**CROSSROADS LANDFILL**

RE: Supplemental Information in Support of Phase 14 Solid Waste Permit Application  
License Application #S-010735-WD-YB-N  
Crossroads Landfill - Norridgewock, Maine

**RE: RESPONSE TO 9 SEPTEMBER 2020 MEDEP COMMENTS  
PHASE 14 SOLID WASTE PERMIT APPLICATION # S-010735-WD-YB-N  
CROSSROADS LANDFILL - NORRIDGEWOCK, MAINE**

Response to 9 September 2020 MEDEP Comments  
WMDSM Phase 14 Solid Waste Permit Application

TITLE  
**PROPOSED WATER QUALITY MONITORING PROGRAM**

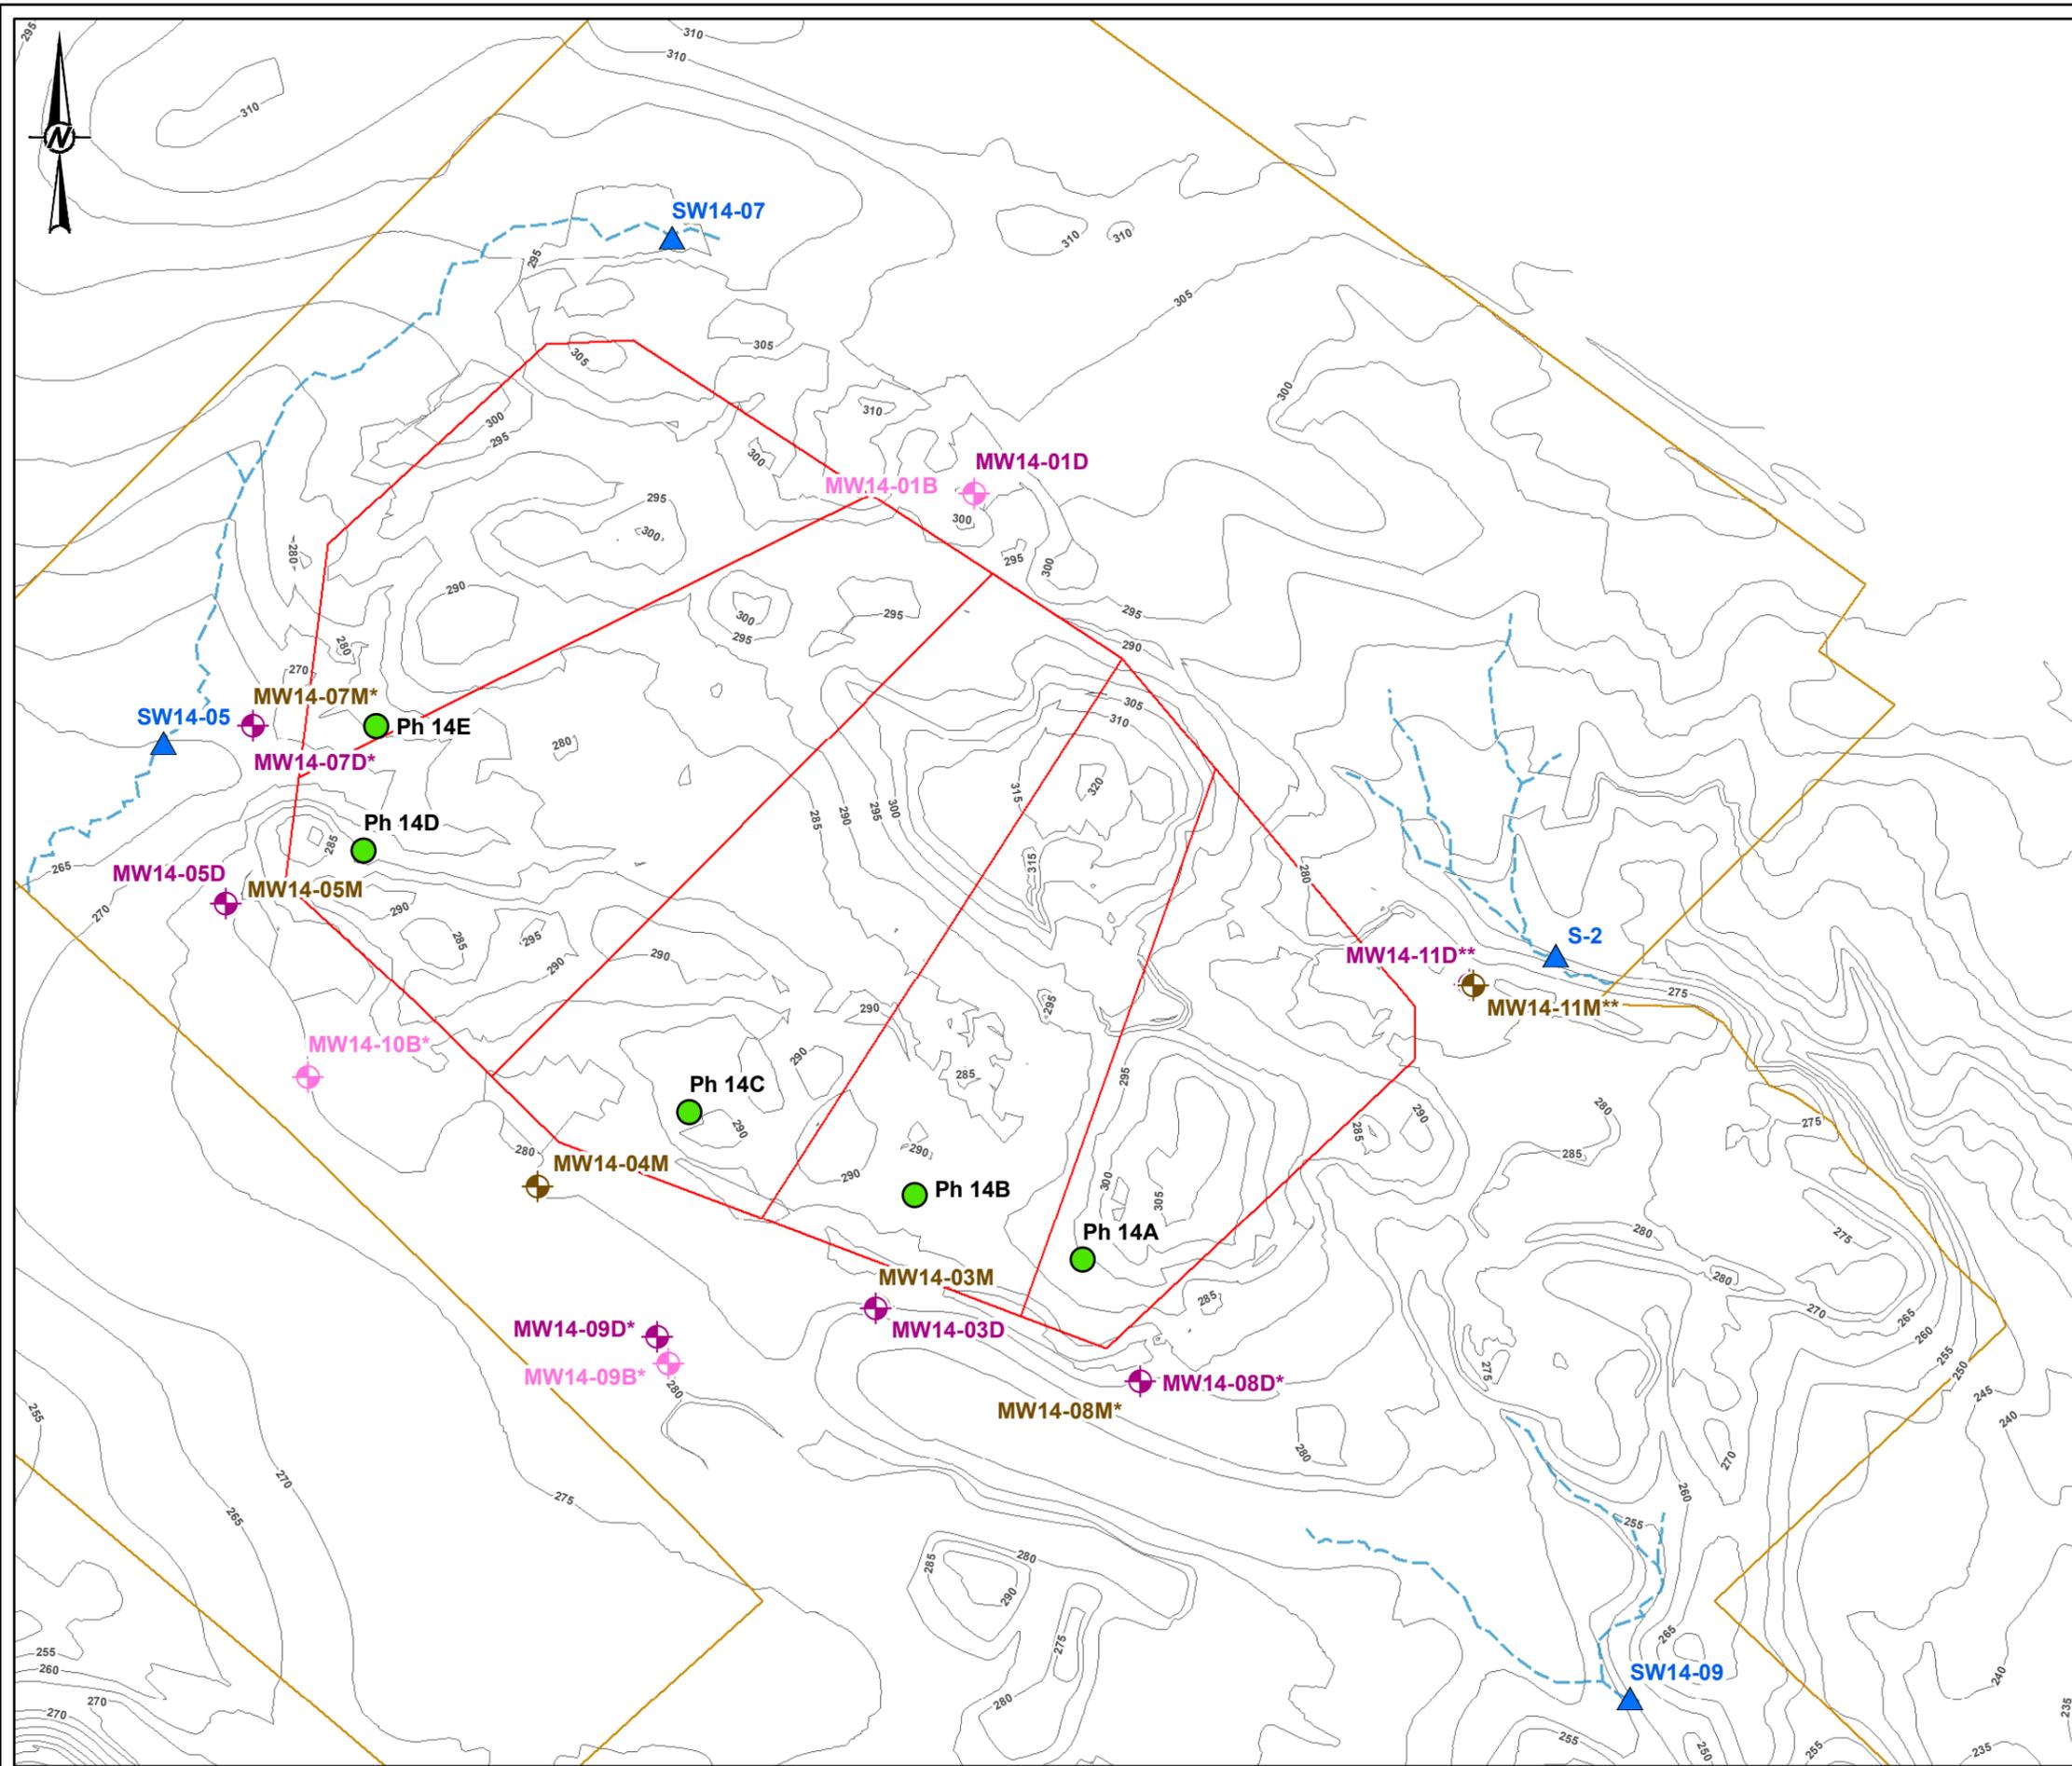
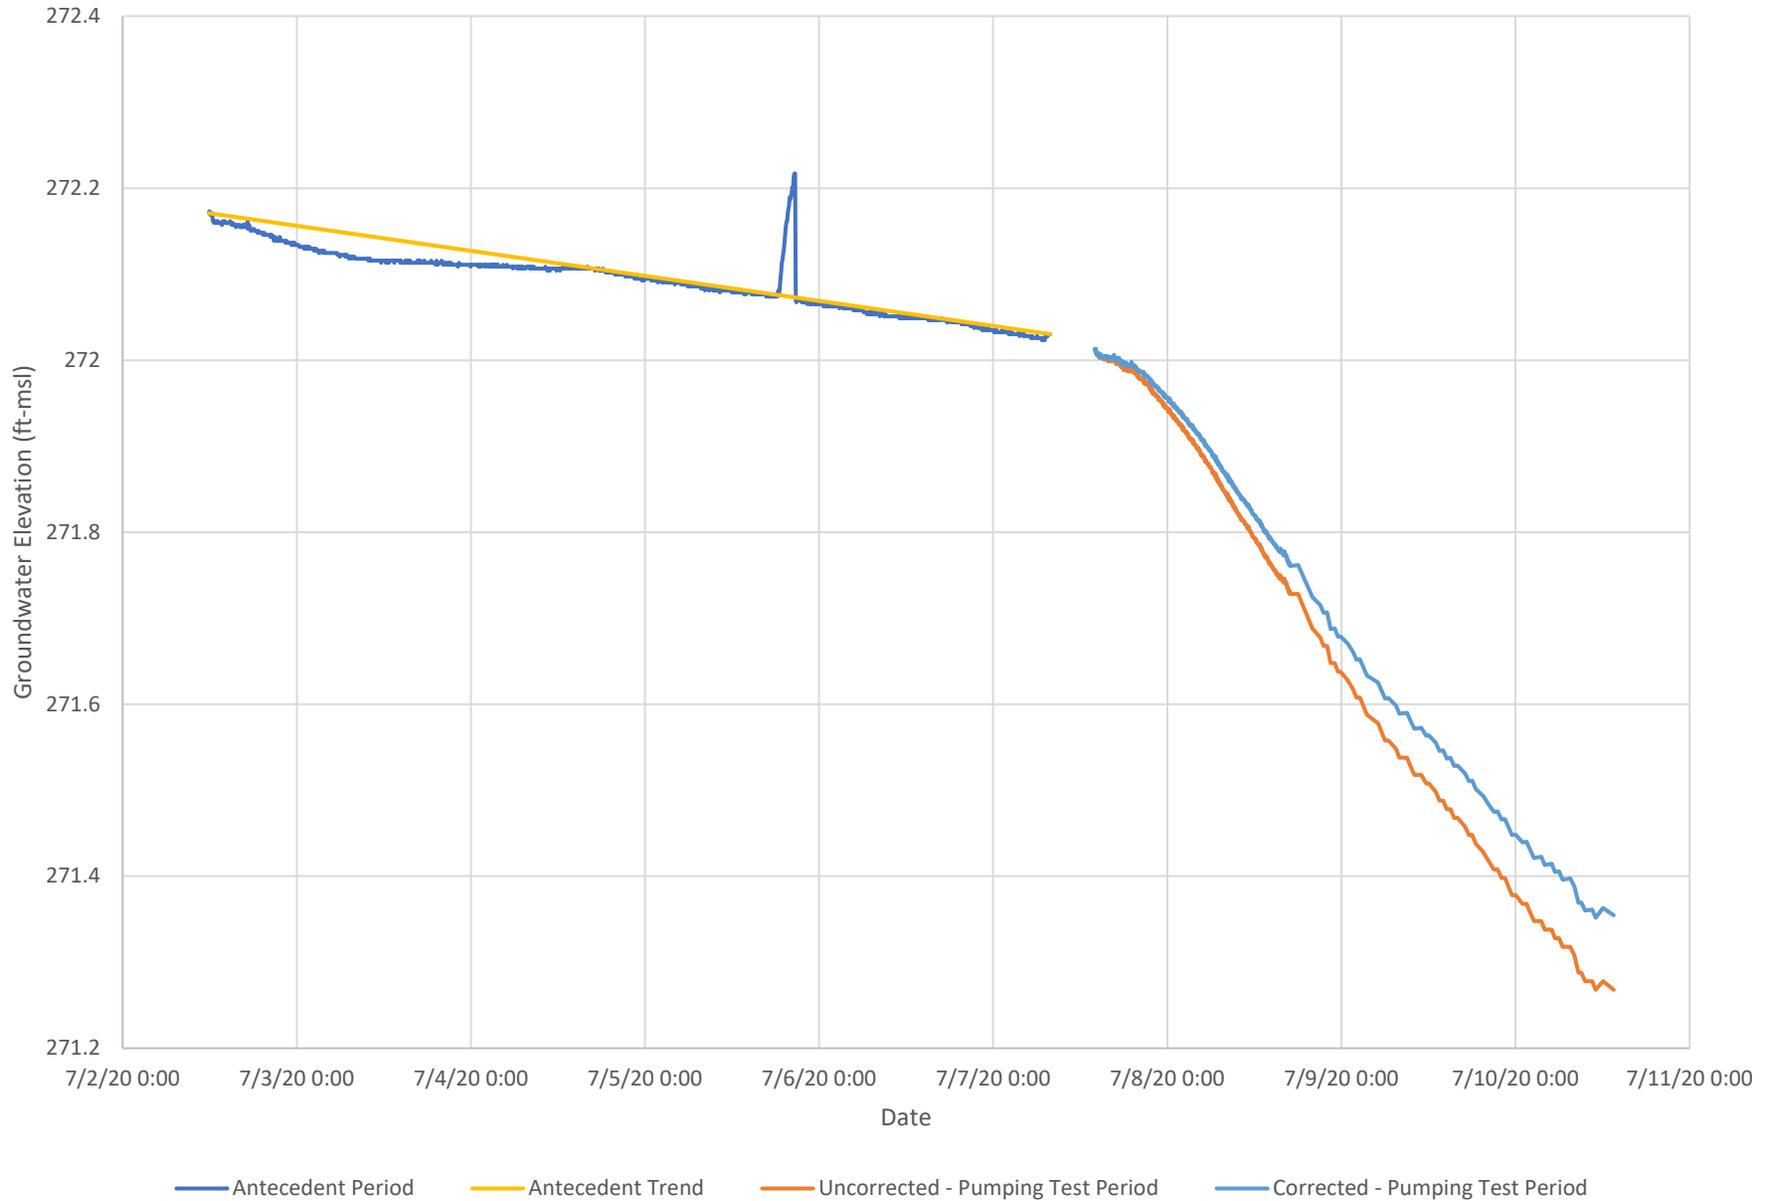
3	The uncertainty regarding fracturing in the clay, particularly in the stiff clay, would be alleviated by scarification of clays, expansion of the area of proposed fill and the addition of compacted clay in the northwestern part of Phase 14, as WMDSM proposed in the above referenced April meeting to satisfy rule requirement ch.401.2(D)(3).	Attachment B includes a discussion of additional measures such as scarification/recompaction of the stiff upper clay and the addition of silt-clay borrow in specific areas where the lower soft clay is absent.
4	6.1 Proposed groundwater water quality monitoring program. Based on the till equipotential contour lines (Figure 13a of volume III), the well MW14-04D is not downgradient of the likely discharge point, Ph14C, so MEDEP has indicated a new location for MW14-4D in the figure below. MEDEP considers that it is not necessary to install new upgradient wells for monitoring. WMDSM should be able to use the PZ-7 or PZ8 well clusters instead of installing new upgradient wells.	WMDSM has modified the proposed water quality monitoring plan (WQMP) to incorporate the new locations for MW14-04D as requested by MEDEP. WMDSM has also modified the proposed WQMP to use PZ-7M and PZ-7D as upgradient monitoring wells as suggested by MEDEP. Attachment A-1 includes revised Tables 6-1 and 6-2 that summarize the revised WQMP and Revised Figure 6-1 illustrating the proposed monitoring locations.

5	<p>Follow-on response to Comment 16 of MEDEP memorandum dated June 22, 2020. MEDEP concurs that with weak vertical gradients, the transport of groundwater from the landfill to the bedrock would probably take a long time, but it would also mean that the water from the landfill would extend out from the landfill for a long distance before entering the bedrock and not intersect the existing bedrock wells. Some indication of this can be seen in the cross-section in Figure 15 of Volume III. There is no flow path from the landfill that intersects the screen of the downgradient bedrock well, MW14-04B. We concur that there appears to be a good hydraulic connection between the bedrock wells, but this does not tell us where the flow lines from the bottom of the landfill to the bedrock are.</p> <p>Two bedrock monitoring wells are required downgradient of Phase 14 so that groundwater released from the landfill is likely to be intercepted by the wells. MEDEP has indicated the locations of these wells in the figure below. Also, MW14-4D is not located downgradient of Ph 14C, the likely release point, and, like the bedrock well, MW14-4B, is not located far enough away for water from a release at Ph14C to intercept its screen, so we have indicated a new location. WMDSM must include two bedrock monitoring wells in its proposed water quality monitoring program that satisfy MEDEP concerns.</p>	WMDSM has modified the proposed WQMP to incorporate the two bedrock monitoring well locations requested by MEDEP and the revised location for till monitoring well MW14-04D. Please see Attachment A-1 for revised Tables 6-1 and 6-2 that summarize the revised WQMP and Revised Figure 6-1 illustrating the proposed monitoring locations.

Attachment A-3: MW14-05M and  
MW14-05D Response to  
Precipitation

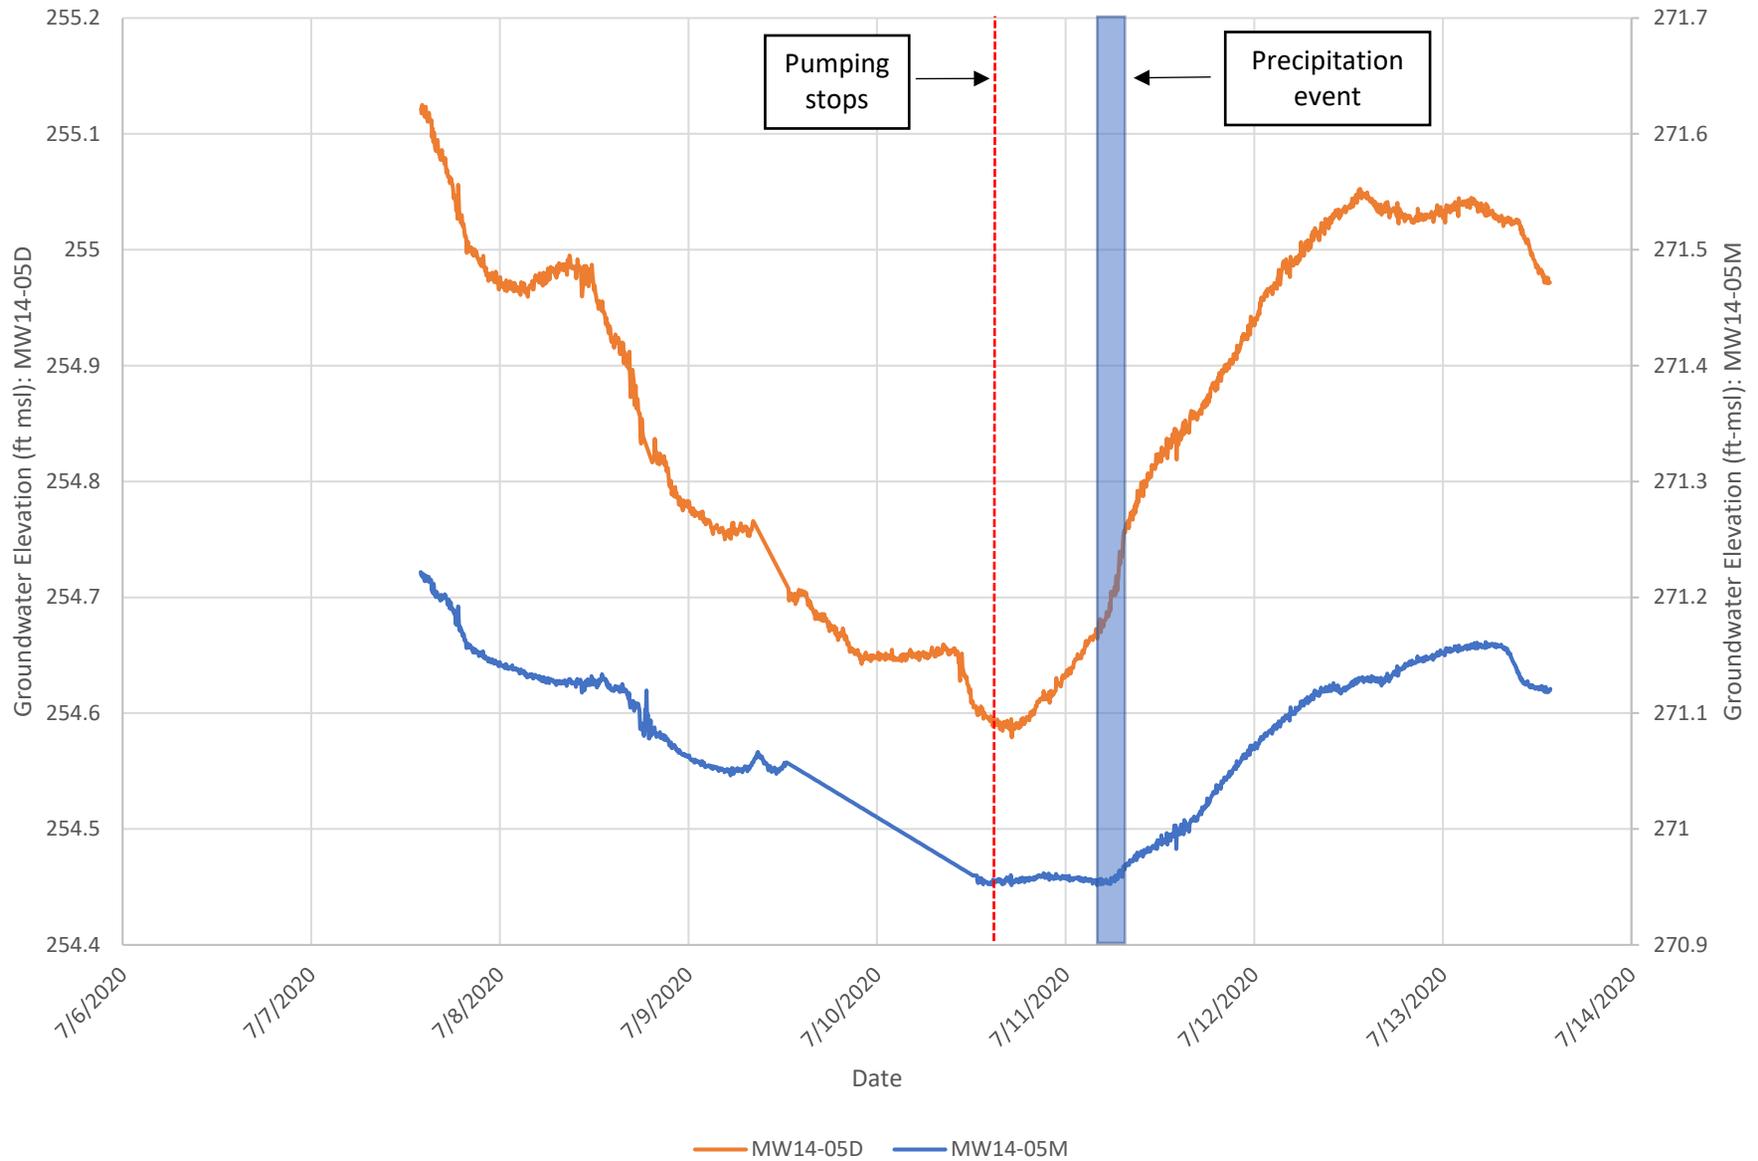
16	<p>5.2.3 Glacial till, second paragraph. The till in the Phase 14 area may be primarily recharged from the north, northeast (outside of Phase 14 area, we presume), but please explain the rapid response of water elevations to the rain event in several till wells.</p>	<p>Please see response to comment 15. It is Golder’s opinion that the response in the till is consistent with the expected response of a confined aquifer. Recharge of the till primarily occurs in areas upgradient of Phase 14 where Presumpscot clays are absent. Head changes in response to precipitation are rapidly transmitted in confined units. Golder also notes that the July 11 precipitation event was a localized thunderstorm. The timing and intensity of the precipitation event in the till recharge area likely differed from timing and intensity of the precipitation in the immediate Phase 14 area.</p>
17	<p>Follow-on response to Comment 27 of MEDEP memorandum dated June 22, 2020. WMDSM’s response states that they provide (in Section 4.0) a comparison of the current Phase 14 time-of-travel parameters to the parameters used in Gerber’s 1996 groundwater model, but other than some discussion on porosity values (which weren’t used in the original Phase 14 time-of-travel estimates), we could not find any comparison or evaluation of the 1996 model. Section 6.4 of Volume III uses the Gerber modeling results to justify the Phase 14 time-of-travel estimations, so it is appropriate to ask for confirmation of the applicability of the model. Could they be more specific on the location of the validation of using the 1996 model results to support Phase 14?</p>	<p>To clarify, Golder did not rely on the Gerber results to inform its analysis of the time of travel for the Phase 14 project. The Phase 14 time of travel analysis is independent of Gerber’s results and based on the specific hydrogeologic conditions identified in the Phase 14 area. Golder noted that the results for Phase 14 were consistent with the prior results, but the intent of the comparison was to highlight the consistency of the results of the time of travel analyses completed by Golder and Gerber, not to “justify” or “validate” the Phase 14 analyses.</p>

Comment #	MEDEP Comment – September 9,2020	WMDSM Response
		<p>wells screened in a “leaky” aquifer will differ from drawdown curves for wells screened in a “non-leaky” aquifer. Hantush developed type curves for leaky aquifers that incorporates leakance and its effect on the shape of drawdown curves. The amount of leakance is a function of the aquitard vertical hydraulic conductivity. Through matching of the Hantush type curves, a well function is derived, from which an aquitard hydraulic conductivity value can be calculated.</p> <p>There are other methods developed by Hantush that allow for calculation of a Kr (horizontal K) and Kz (vertical) ratio for the pumped aquifer when the test includes partially penetrating wells, but that was not the focus of this pumping test or analysis. The ratio of Kr/Kz in the till is expected to be close to one given the till lithology.</p>
15	<p>5.2.2 Presumpscot Clays, last paragraph. “...the Presumpscot clays impedes most meteoric recharge...” We noted that the response of the water levels in the background wells to the July 11 precipitation event indicated that the till responded quickly which might indicate rapid transmittal of the water across the clay. MW14-05D shows a very similar increase due to the precipitation that comes at virtually the same time as the clay well MW14-05M, further supporting rapid transmittal of water across the clay to the till. Please provide your thoughts on the response of till water to the precipitation event.</p>	<p>Evaluation of the recovery hydrographs for the background piezometers (Figure D-4a of the Supplemental Submittal) are useful for evaluating the relative response of the hydrostratigraphic units to precipitation. The response of the sand well (PZ-10S) to the precipitation event appears slightly delayed from the on-set of precipitation and of limited magnitude (approximately 0.1 ft). There was no observable response to precipitation in clay well PZ-10M to the precipitation event. The initial response in till well PZ-10D is almost simultaneous with the on-set of precipitation and of greater magnitude (approximately 0.2 ft) than the sand well. These observations suggest that the response of the till well to precipitation is independent of the response in the sand and clay (i.e., the magnitude of the response in the sand and clay to the precipitation is lower and occurs after the response in the till, therefore, they cannot be the cause of the response in the till).</p> <p>It is Golder’s opinion that the response in the till is consistent with the expected response of a confined aquifer, where head changes are rapidly transmitted over long distances. The response to the precipitation is likely from recharge of the till in areas upgradient of Phase 14 where Presumpscot clays are absent.</p> <p>Attachment A-3 includes a hydrograph of recovery data for MW14-05D and MW14-05M plotted at the same scale. Golder notes that the apparent response to the precipitation event in the clay well MW14-05M is both temporally delayed and of significantly less magnitude than the response in till well MW14-05D. Furthermore, the clay well does not respond to the cessation of pumping in a similar manner as the till well, which indicates a lack of hydraulic communication between these two units. Similar to the background wells, it is Golder’s opinion that the response in MW14-5D due to the precipitation event is not due to rapid transport through or across the clay.</p>
